**TASK ORDER 0003 UNDER  
CONTRACT DTNH22-13-D-00298**

**PEER REVIEW OF “COMMERCIAL MEDIUM- AND HEAVY-  
DUTY (MD/HD) TRUCK FUEL EFFICIENCY TECHNOLOGY  
STUDY – REPORT #3”\***

**PEER REVIEW REPORT  
June 18, 2015**

*Submitted to:*  
**U.S. Department of Transportation  
National Highway Traffic Safety Administration**  
Washington, DC 20590  
Attn: James Maclsaac  
[James.Maclsaac@dot.gov](mailto:James.Maclsaac@dot.gov)

**Suggestions on analyzing HD simulation data**

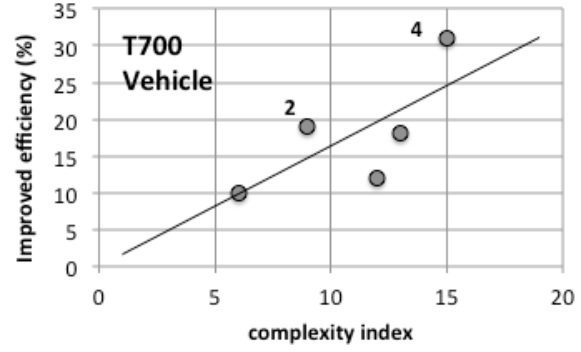
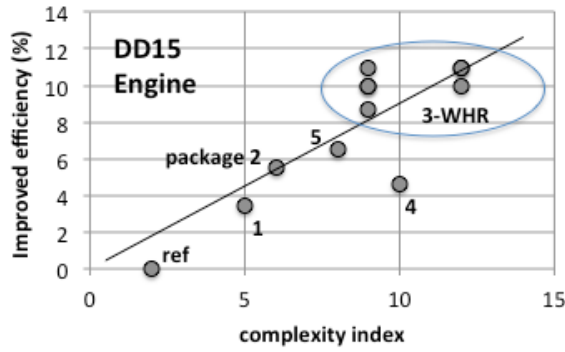
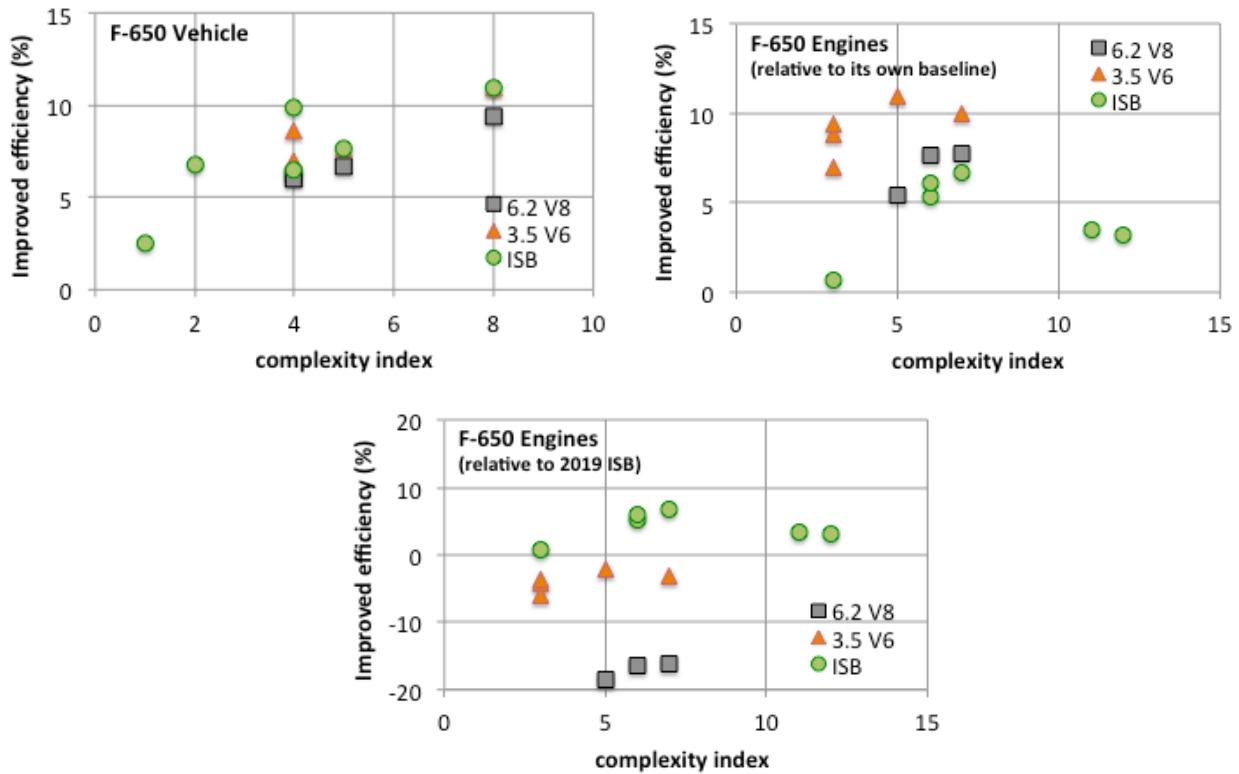
Suggested improvements: The data may be rearranged to show more clearly the merit of each the technologies and the result of combinations. One way is illustrated in the figure below for the HD DD15 engine and the T700 vehicle, and later for the engines and F-650 vehicle. The tables seeks to:

- Clearly highlight the technology content of each package and provide a better overview of the combinations,
- Put a complexity weight factor for each package alongside the reported fuel benefit. Here GREEN=1, YELLOW=2, RED=3 (the designations are the reviewer’s estimations and are inserted primarily for illustration purposes).
- Charts may be drawn indicating the relation between the fuel and complexity index such as indicated below.
- The tables are drawn for one of the drive cycles (NESCAFF for the HD and WHVC for the MD – each at 50% load).

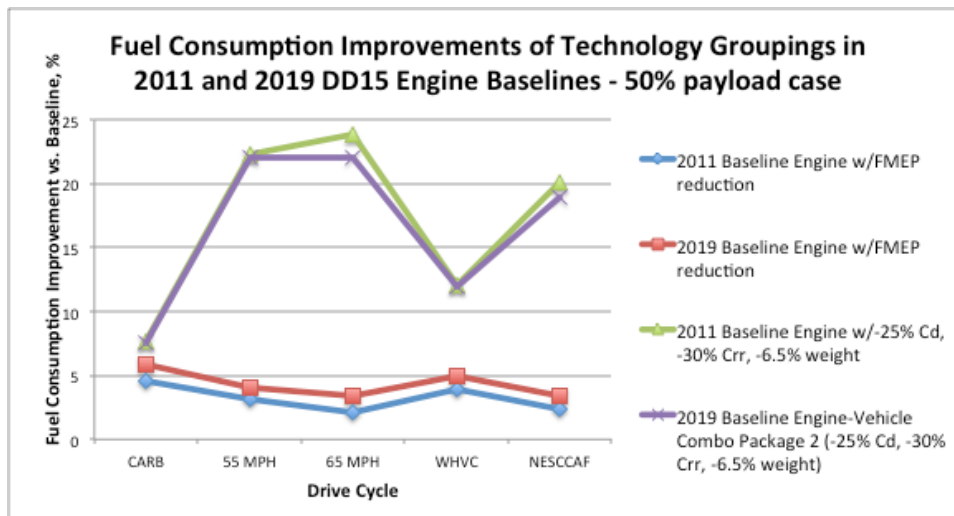
**Interactions of Combined Technologies.** Analysis of technology interactions has not been specifically presented in the report. For example, is fuel consumption due to a reduction in Crr affected by different levels of the coefficient of aerodynamic drag, Cd, on a given vehicle? Typically, we would say the answer is no, given the definitions of Crr and Cd embedded in the modeling. One way to explore additive effects on a very macro level would be to compare whether a technology, or package of technologies, provides the same level of fuel consumption improvement when applied to two different baselines.

The following graph shows the percent improvement in fuel consumption due to the same engine friction reduction (FMPEP) for both the 2011 and 2019 baseline engines, across all drive cycles. The 2011 baseline DD15 + FMPEP improvement (case #11 in Report #1) is compared to the 2011 baseline; likewise, the 2019 baseline DD15 + FMPEP improvement (DD15 package #1 in Report #3) is compared to the 2019 baseline engine model.

Similarly, the combined effects of a 25% reduction in Cd, 30% reduction in tire rolling resistance, and 6.5% reduction in empty vehicle weight can be compared by adding the individual contributions to establish an improvement in fuel consumption versus the 2011 baseline (addition of cases II, JJ, and KK-6.5% from Report #1) compared to the T-700 Combined Engine-Vehicle package #2 in Report #3 which combines the same technologies with the 2019 baseline engine model.

From these results, we would be likely to conclude that these technologies are largely additive, with small differences due to simulation uncertainties, modeling assumptions, or perhaps, real differences in interactions. The friction reduction cases show a consistently greater improvement when applied to the 2019 baseline versus the 2011 baseline engine. Vehicle weight, rolling resistance, and aerodynamic drag are expected to be additive if the baselines are similar enough, as the 2011 and 2019 DD15 models appear to be. More interesting cases could consider combined engine modifications and vehicle technologies, such as substituting the 2019 DD15 engine package 2 (downspeeding + partial FMEP reductions) into the T-700 combo package #2 (25% reduction in Cd, 30% reduction in tire rolling resistance, and 6.5% reduction in empty vehicle weight) to compare with an analogous 2011 package, which may show some evidence of interactions.

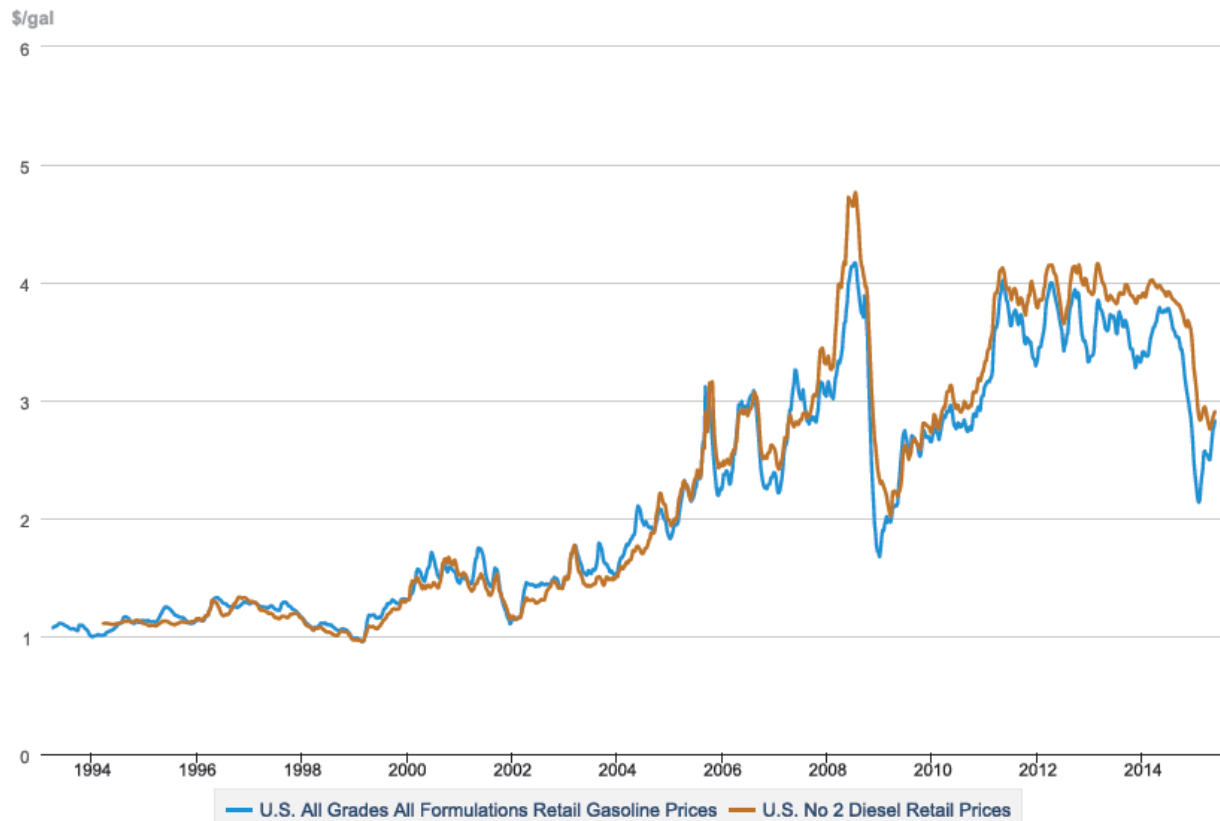
- Difference in vehicle purchase price (V-6 and V-8 both \$9000 less expensive than the diesel);
- Differences in fuel consumption between engines;
- Cost of gasoline (taken here as the base);
- Price difference between the cost of gasoline and diesel fuel.

- Annual mileage;
- Mix and weighting of drive cycle simulations.

Given the variety of applications for this vehicle class, it is difficult to make a case for other than equal weighting of the 6 drive cycles simulated in the study. An increase in assumed annual mileage will make a more favorable case for diesel engines; an annual mileage decrease will favor gasoline engine versions. Including annual mileage as a variable rather than as a constant in the calculations could also be of interest, but it is probably unlikely to significantly change the conclusions of the existing analysis based on 25000 miles annually.

Certainly, the levels and volatility of fuel prices are key to the payback time required to overcome the purchase price differential between gasoline and diesel vehicles. Another version of Figure 4.1 shown in Report #3 comes from the U.S. Department of Energy, Energy Information Administration website (eia.gov), and shows the history of both gasoline and diesel prices in the U.S. (from which Figure 4.1 in Report #3 can be derived). During the period from about 2011 to the end of 2014, volatility of gasoline price has largely driven the differences between the costs of the two fuels, although both fuels experienced significant price drops in the first half of 2015.

### Suggestions on analyzing HD simulation data

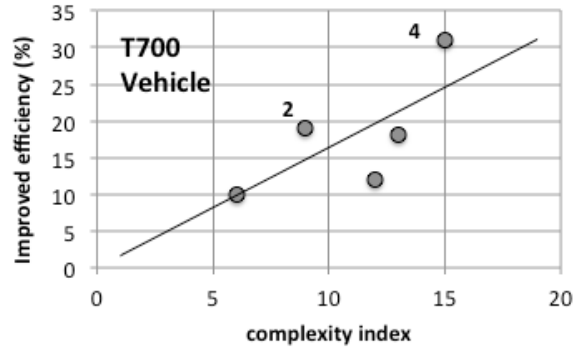
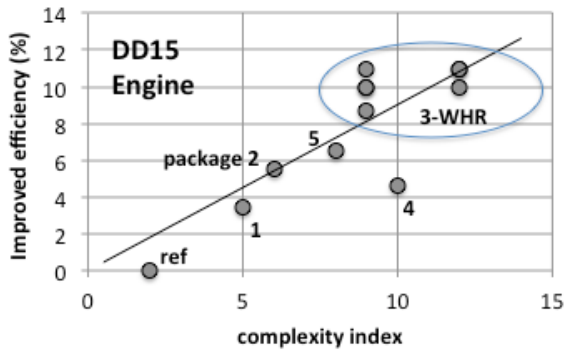
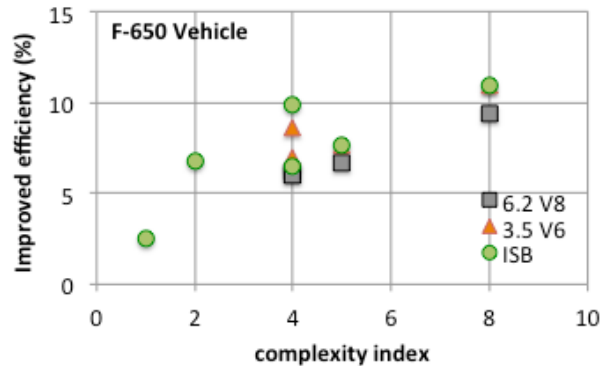
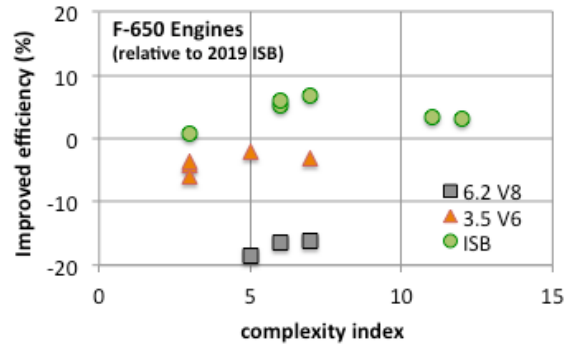
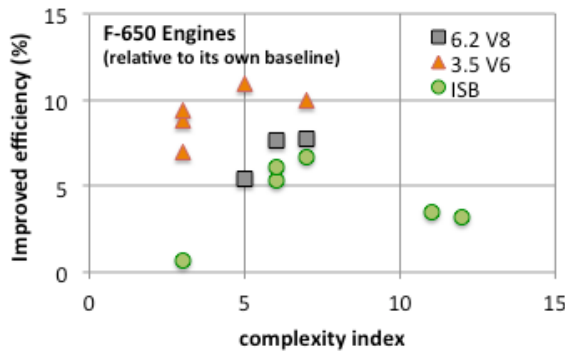
Suggested improvements: The data may be rearranged to show more clearly the merit of each the technologies and the result of combinations. One way is illustrated in the figure below for the HD DD15 engine and the T700 vehicle, and later for the engines and F-650 vehicle. The tables seeks to:

- Clearly highlight the technology content of each package and provide a better overview of the combinations,
- Put a complexity weight factor for each package alongside the reported fuel benefit. Here GREEN=1, YELLOW=2, RED=3 (the designations are the reviewer's estimations and are inserted primarily for illustration purposes).
- Charts may be drawn indicating the relation between the fuel and complexity index such as indicated below.
- The tables are drawn for one of the drive cycles (NESCAFF for the HD and WHVC for the MD – each at 50% load).

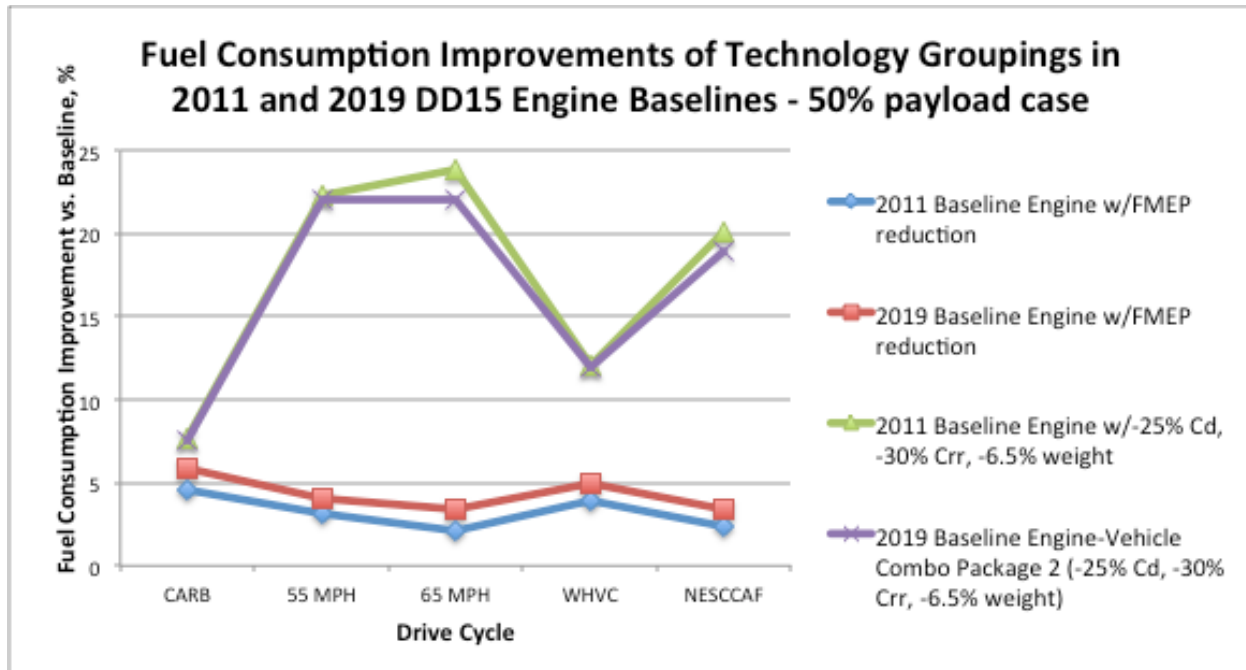
The following graph shows the percent improvement in fuel consumption due to the same engine friction reduction (FMEP) for both the 2011 and 2019 baseline engines, across all drive cycles. The 2011 baseline DD15 + FMEP improvement (case #11 in Report #1) is compared to the 2011 baseline; likewise, the 2019 baseline DD15 + FMEP improvement (DD15 package #1 in Report #3) is compared to the 2019 baseline engine model.

Similarly, the combined effects of a 25% reduction in Cd, 30% reduction in tire rolling resistance, and 6.5% reduction in empty vehicle weight can be compared by adding the individual contributions to establish an improvement in fuel consumption versus the 2011 baseline (addition of cases II, JJ, and KK-6.5% from Report #1) compared to the T-700 Combined Engine-Vehicle package #2 in Report #3 which combines the same technologies with the 2019 baseline engine model.

From these results, we would be likely to conclude that these technologies are largely additive, with small differences due to simulation uncertainties, modeling assumptions, or perhaps, real differences in interactions. The friction reduction cases show a consistently greater improvement when applied to the 2019 baseline versus the 2011 baseline engine. Vehicle weight, rolling resistance, and aerodynamic drag are expected to be additive if the baselines are similar enough, as the 2011 and 2019 DD15 models appear to be. More interesting cases could consider combined engine modifications and vehicle technologies, such as substituting the 2019 DD15 engine package 2 (downspeeding + partial FMEP reductions) into the T-700 combo package #2 (25% reduction in Cd, 30% reduction in tire rolling resistance, and 6.5% reduction in empty vehicle weight) to compare with an analogous 2011 package, which may show some evidence of interactions.

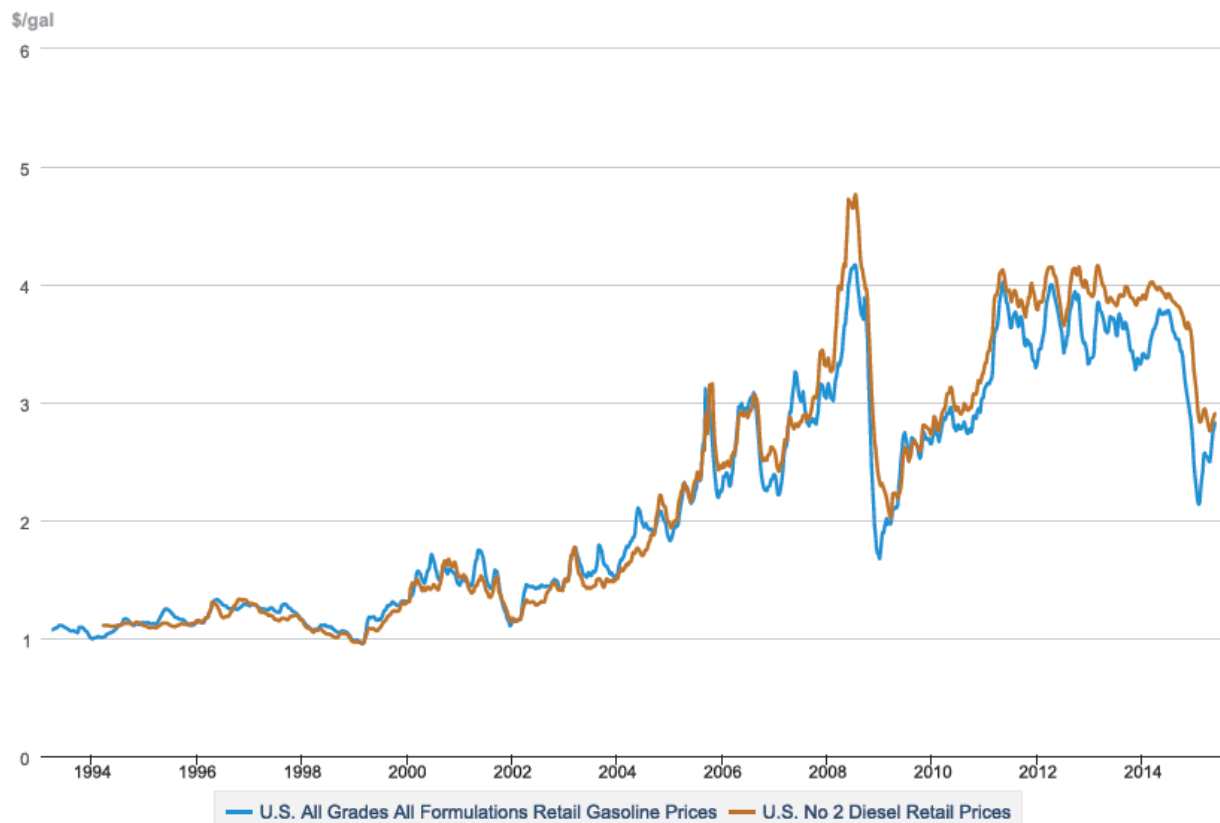
- Difference in vehicle purchase price (V-6 and V-8 both \$9000 less expensive than the diesel);
- Differences in fuel consumption between engines;
- Cost of gasoline (taken here as the base);
- Price difference between the cost of gasoline and diesel fuel.

- Annual mileage;
- Mix and weighting of drive cycle simulations.

Certainly, the levels and volatility of fuel prices are key to the payback time required to overcome the purchase price differential between gasoline and diesel vehicles. Another version of Figure 4.1 shown in Report #3 comes from the U.S. Department of Energy, Energy Information Administration website (eia.gov), and shows the history of both gasoline and diesel prices in the U.S. (from which Figure 4.1 in Report #3 can be derived). During the period from about 2011 to the end of 2014, volatility of gasoline price has largely driven the differences between the costs of the two fuels, although both fuels experienced significant price drops in the first half of 2015.
